2000 & LATER DODGE TRUCKS & VANS

46RE INTERNAL LINKAGE AND SAFETY NEUTRAL SWITCH CHANGES

Figure 1

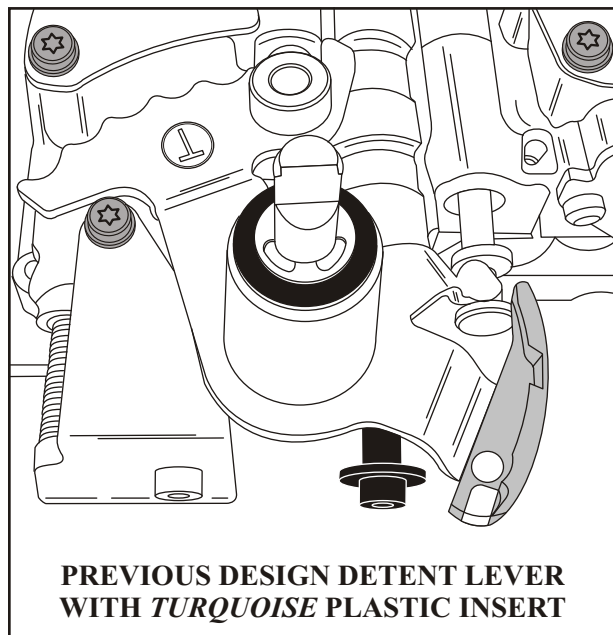
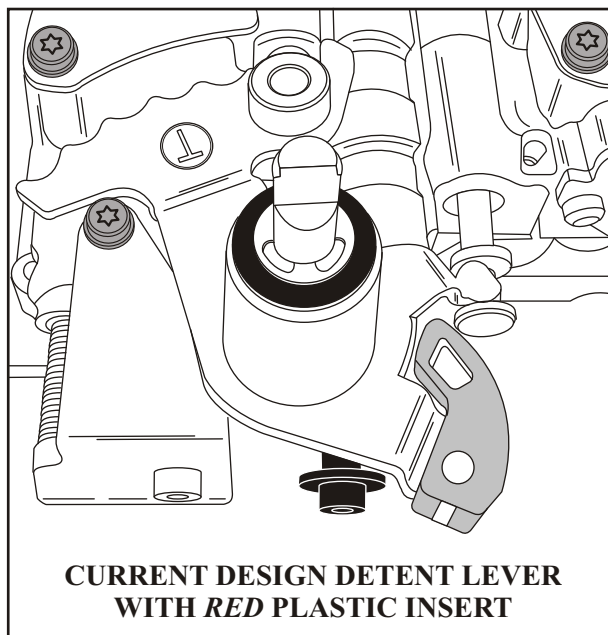
CAUSE: The safety neutral switch and the valve body detent lever changed for the 2000 model year. The switch is longer and the detent lever dimensionally changed to accommodate the new switch. Figures 1 and 2 show the dimensional differences between the previous and current design detent levers. Figures 3 and 4 illustrate the correct and incorrect assembly using the short switch. Figure 5 shows the correct assembly using the long switch.

CORRECTION: The detent lever with the *turquoise* plastic insert goes with the *short* safety neutral switch. The detent lever with the *red* plastic insert goes with the *long* safety neutral switch.
